CERTIFICATE OF APPROPRIATENESS

Applicant: Gary Naylor of Gulf Coast Windows for Mark and Cynthia Heater, owner

Property: 7707 Lakewind Street, tract 35, block 21, Glenbrook Valley Subdivision. The property includes a historic 3,469 square foot, one-story wood frame single-family residence and an attached garage situated on a 35,524 square foot interior lot.

Proposal: Alteration – Replace seven original aluminum windows on the front elevation of a Contributing residence with matching composite windows.

WINDOW SCHEDULE and DIAGRAM

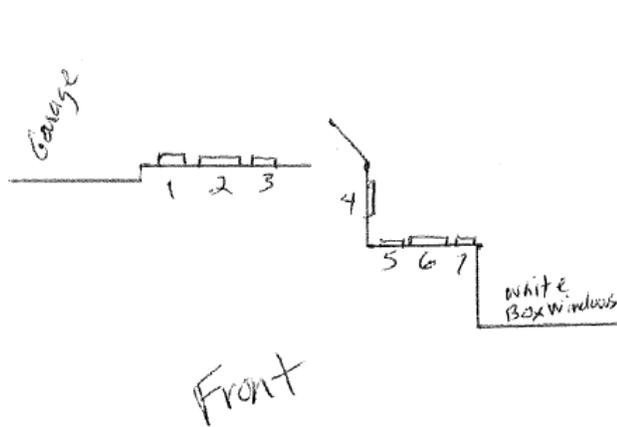
These windows were noted to be in good condition when staff performed a site visit associated with another COA granted for this property in April.

No evidence has been submitted to indicate that the existing windows are damaged beyond repair.

- (1) The proposed activity must retain and preserve the historical character of the property;
The replacement of undamaged historic windows undermines the historic character of the property.

- (4) The proposed activity must preserve the distinguishing qualities or character of the building, structure, object or site and its environment;
- (5) The proposed activity must maintain or replicate distinctive stylistic exterior features or examples of skilled craftsmanship that characterize the building, structure, object or site;
The proposal to replace the existing aluminum windows represents a failure to maintain the structure's distinctive stylistic features. There is no damage present on the windows that would warrant their replacement.

- (9) The proposed design for any exterior alterations or addition must not destroy significant historical, architectural or cultural material and must be compatible with the size, scale, material and character of the property and the area in which it is located;
There is no damage present on the windows that would warrant their replacement.

Recommendation: Denial – Does not satisfy criteria

PROPOSED REPLACEMENT WINDOW SECTION

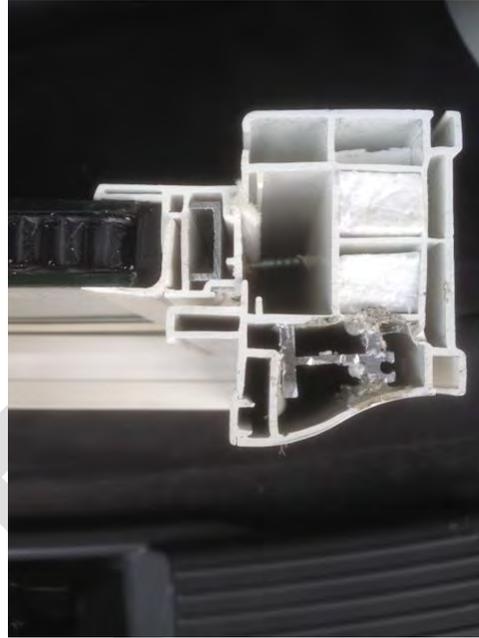
Windows/Doors: The applicant proposes to replace 7 windows on the front elevation of a contributing structure. The replacement windows will consist of composite material and will not require modification of the window openings.

Staff performed a site visit associated with a COA granted in April and found no damage on the windows at that time.

The applicant has not submitted any specific evidence indicating the windows are damaged beyond repair.
